Rhode Island Public Utilities Commission 89 Jefferson Blvd. Warwick, RI. 02888 By Electronic Transmission

I wish to add some additional points to topics discussed during today's (11.1.2021) hearing of the EFSB. As one of the residents abutting the proposed Camp Ave cable installation, there are concerns of traffic, noise, and road closures during this period of time. These were referred to during the meeting as temporary issues that may be mitigated by working with the town. However, the current ongoing construction replacing the gas main requires Camp Ave to be closed during this construction, and a detour around Windward Walk. The planned entrance of the cables to Camp Avenue from QBP will require a detour through Seabreeze Drive, as it will block the entrance to Windward Walk. Seabreeze Drive is narrower than Windward Walk, with residents using on street parking.

Revolution Wind
 Powered by Ørsted & Evenues
 Existing and Proposed Screening Camp Ave at Shore Acres Ave North Electrons Phode Island
 Attachmer EFSB 2-1

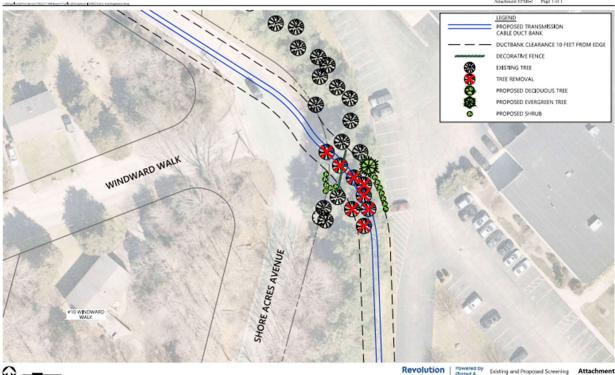
The current proposed plan replacing these mature trees with shrubbery and a small fence as detailed in EFSB Data Requests, set 2, dated October 5, 2021 response to 2-1(6):

"6. If the route through the residential area is used, we will lose the current buffer zone between the street and the industrial park, which was placed to reduce sight lines, noise, and light pollution. What mitigation is planned for this?

Shrubs and a small fence will not provide the buffer needed to reduce light and noise pollution to our neighborhood. This will directly affect sightlines to the windows on the rear of my house at 10 Windward Walk.

Revolution Wind has been working with the property owner at 135 Circuit Drive to specifically address the installation of the transmission line and provide a robust landscaping solution. Attachment EFSB 2-1 depicts a draft landscaping plan developed to maintain screening while safely operating the

transmission line. Eight existing trees ranging in size from 6 inches to 18 inches in diameter will be removed in the hedgerow separating 135 Circuit Drive and Shore Acres Avenue where the Onshore Transmission Cable will be constructed. This area will be restored by replanting with 13 shrubs and one tree and a decorative fence over the duct bank that will serve to replace the buffer as the new plantings mature. These plantings will reduce sight lines, noise and light pollution."
